Access Compliance Report

Public Rights-of-Way

(Curb Ramps)

Intersection ID: 52927	Main Street: EMORY_OAK_DR	Cross Street: GRAY_OAK_LN	Location: W
ADA ID: 36FDC5344519	Ramp Type: BlendTrans1	Initial Pass/Fail: Fail	Overall Compliance: No
Severity Score: 10			
Codes/Mitigation Info/Possible Solution		Field Measurements/Component Compliance

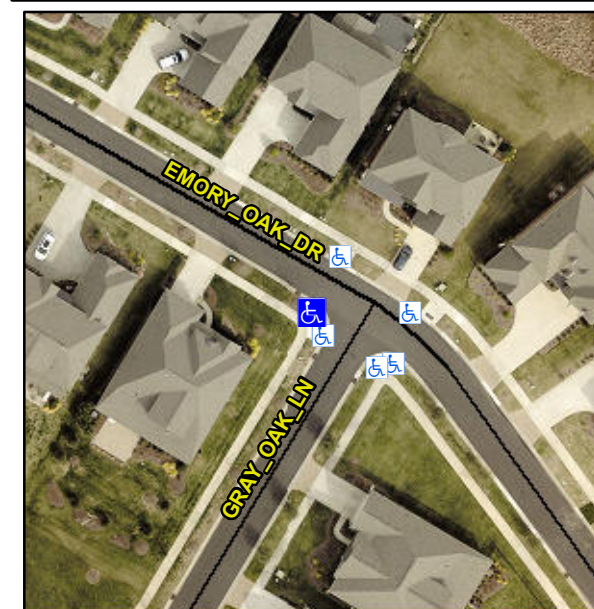
Compliance	Description	Data	Compliance	Description	Data
N/A	Ramp Length (in)	100.5	Yes	BlendTrans Slope (%)	3.2
No	Ramp Width (in)	46.5	Yes	BlendTrans XSlope (%)	2.9
N/A	Flare Type LT	N/A	N/A	Flare Type RT	N/A
N/A	Flare Slope LT (%)	N/A	N/A	Flare Slope RT (%)	N/A
N/A	Flare Traversable LT?	N/A	N/A	Flare Traversable RT?	N/A
N/A	Landing Length (in)	N/A	N/A	DWS Provided?	N/A
N/A	Landing Width (in)	N/A	N/A	DWS Contrast?	N/A
N/A	Landing Slope (%)	N/A	N/A	DWS Length (in)	N/A
N/A	Landing X Slope (%)	N/A	N/A	DWS Full Width?	N/A
N/A	Landing Curb? (Y/N)	N/A	N/A	DWS Offset (in)	N/A
N/A	Shared Landing?	N/A			
N/A	Gutter Ponding?	N/A	N/A	Gutter Slope (%)	N/A
N/A	Gutter Lip Ht (in)	N/A	N/A	Gutter X Slope (%)	N/A
N/A	Painted X Walk1?	No	N/A	Painted X Walk2?	N/A
	X Walk 1 Direction	To NE		X Walk 2 Direction	N/A
	X Walk 1 Width (in)	N/A		X Walk 2 Width (in)	N/A
	X Walk 1 Slope (%)	4.3		X Walk 2 Slope (%)	N/A
	X Walk 1 X Slope (%)	4.1		X Walk 2 X Slope (%)	N/A

N/A	Ramp inside XWalk1?	N/A	N/A	Ramp inside XWalk2?	N/A
	Road Slope (%)	4.1		Clear Space?	N/A
	Road X Slope (%)	4.3	N/A	Clear Space to XWalk (in)	N/A
N/A	Any Obstructions?	N/A	N/A	Storm Grate/Utility Hazard?	N/A
	Obstruction Type			Storm Grate/Utility Type	
		N/A			N/A
			Yes	Surface Condition? (G/P)	Good
			N/A	Curb Slope (%)	0.7

Remove & Replace Curb Ramp With Two New Directional Ramps or Equivalent.

R304.5.1
